Project: 226052 DFCI-BIDMC New Cancer Hospital - 1 Joslin Place - Construction
1 Joslin Place
Boston, Massachusetts 02215

RFI #0-PB-127: Tieback Anchor Material Clarification

Reference Drawing QM-701

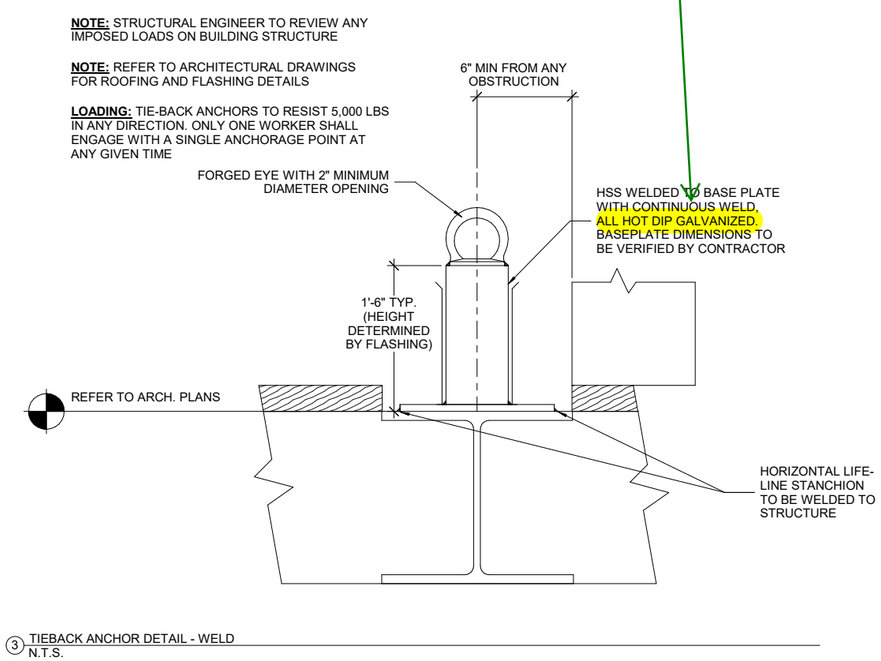
The above-referenced detail calls for the tieback anchors to be hot dip galvanized whereas the BOD Narrative calls for all materials to be stainless steel.

Please review and confirm the tieback anchors can be hot dip galvanized since there is a ROM cost impact for stainless steel anchors of ~$150,000.00.

SCCI: Drawing QM-701 calls for material to be hot dip galvanized

SCCI Question: Please clarify the material for tieback anchors. Detail 3/QM-701 calls for hot dip galvanized. Lerch Bates Basis of Design Narrative dated 10/31/25 calls for stainless steel.

Payette Response (3/9/26): 11 81 23, 2.3 K refers to non-structural hardware. Tieback anchors are structural assemblies. Tieback anchors can be hot dip galvanized.
JYING

Reference Drawing QM-701

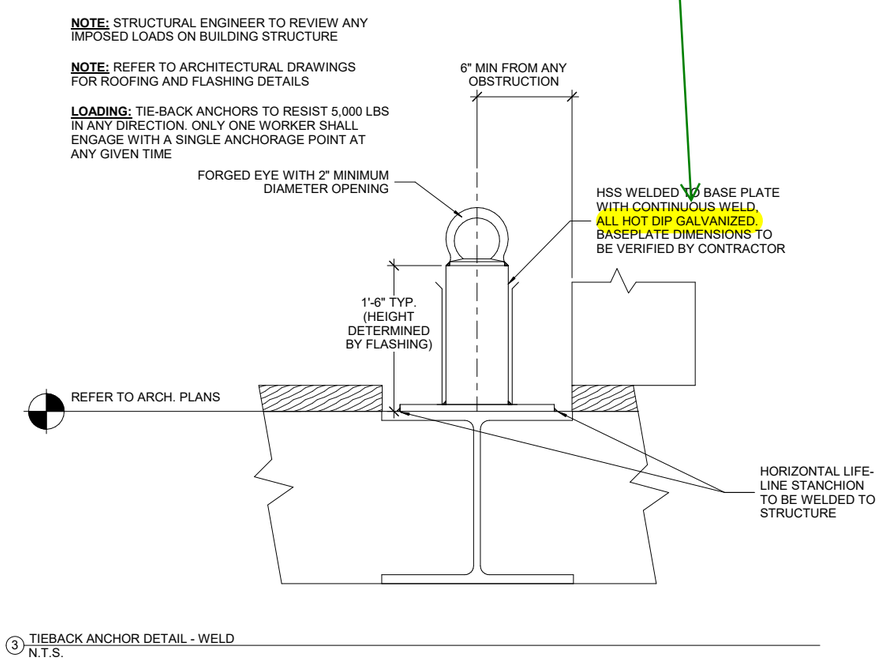
SCCI: Drawing QM-701 calls for material to be hot dip galvanized

SCCI Question: Please clarify the material for tieback anchors. Detail 3/QM-701 calls for hot dip galvanized. Lerch Bates Basis of Design Narrative dated 10/31/25 calls for stainless steel.

11 81 23, 2.3 K refers to non-structural hardware. Tieback anchors are structural assemblies. Tieback anchors can be hot dip galvanized.
